Power Trim Leak Down - 40 Thru 115

This is a revision of Outboard Service Bulletin 93-22. Destroy Bulletin 93-22 and insert Bulletin 93-22A. Changes are underlined.

Mariner And Mercury

1993 and 1994 40 Thru 115

Figure 2. Side View of Manifold.

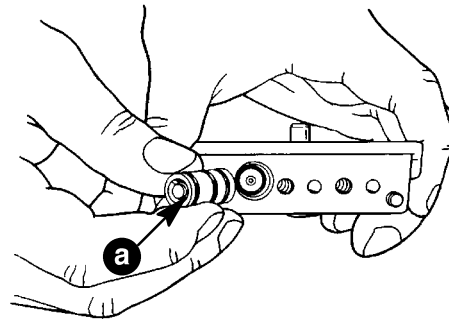
The 1993 and 1994 models listed with power trim date codes 13011 thru 23288 ONLY may experience a very slow up trim rate (one minute or more) with the outboard drifting back down as soon as the UP trim button is released. This failure usually occurs when the unit is new or after three or four weeks of non use. The cause may be a stuck spool inside the sleeve due to an oversize or a hard O-ring on the spool.

To correct, remove the tilt cylinder from the manifold and replace the pilot valve assembly as outlined in the outboard service manual. It is NOT necessary to replace the complete power trim to correct the problem.

Figure 4. Spool Not Stuck.

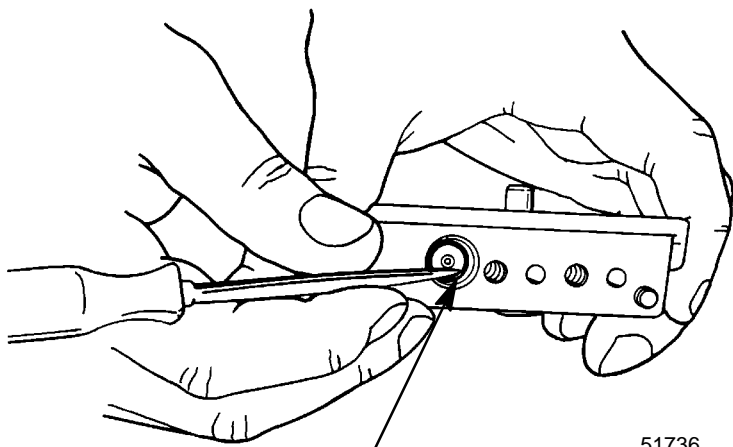
The spool is stuck when the pin end of the spool is protruding out past the end of the sleeve.

Figure 6. Pilot Valve Held Open.

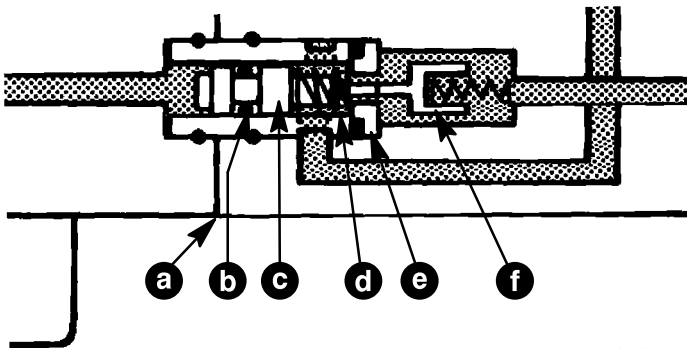
A leak path is created between the UP side of the cylinder and the reservoir, when the spool sticks holding the pilot valve open.

Figure 7. Pilot Valve End.

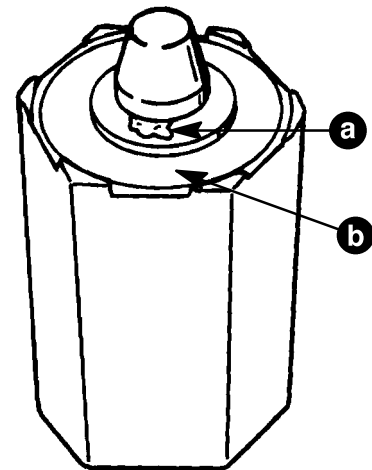
To correct a slow leak down, check for debris between the valve seat and valve.
